SERVICE *No. 974* BULLETIN

DATE: October 19, 1994

Aileron Hinge Inspection and Replacement

PA-31, 31-300, 31-325 Navajo
PA-31-350 Navajo Chieftain
PA-31-350 T1020
PA-31P-350 Mojave
PA-31T3 T1040

SKETCH A

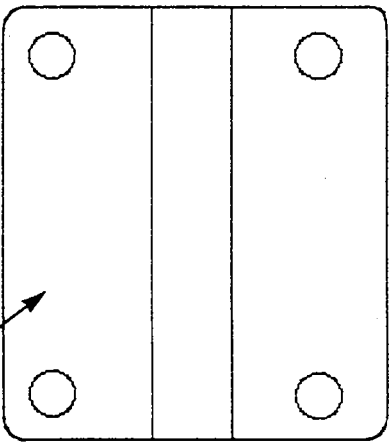
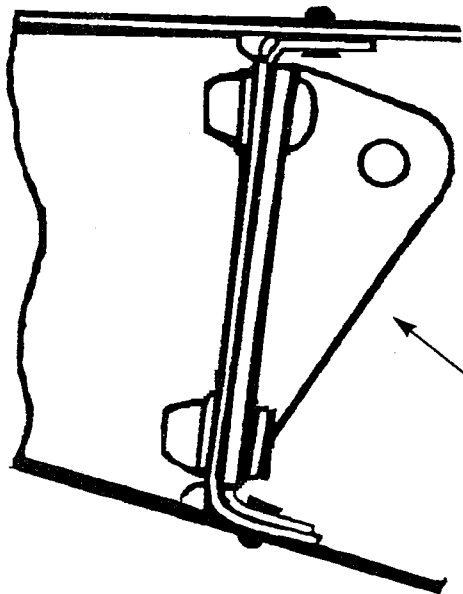
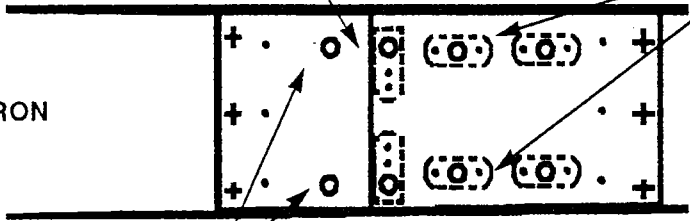
INSPECT:
CRACKS WILL
APPEAR ALONG
SPAR FLANGE
AND AT ATTACH
HOLES.

ADD HOLES & NUTPLATES

EXISTING HINGE HOLES

INSPECT:
CRACKS WILL
APPEAR ALONG
SPAR FLANGE
AND AT ATTACH
HOLES.

6. Install the new Hinge Bracket, Piper Part Number 74461-02 (left) and 74461-03 (right), utilizing three (3) each AN3-5A Bolts, Piper Part Number 401-266, three (3) each AN960-10 Washers, Piper Part Number 407-564, and one (1) each MS24694S53 Flush Screw, Piper Part Number 410-035, per Hinge Bracket.

7. If no cracks are present, it will be necessary to drill additional holes and add two (2) additional nutplates to the existing aileron spar assembly. Temporarily install the new hinge bracket to the aileron spar. Using the new hinge bracket as a template, drill two (2) new .191 inch holes in the spar to match.

INSTALL NEW HINGE
P/N'S 74461-02 (LEFT)
AND 74461-03 (RIGHT)
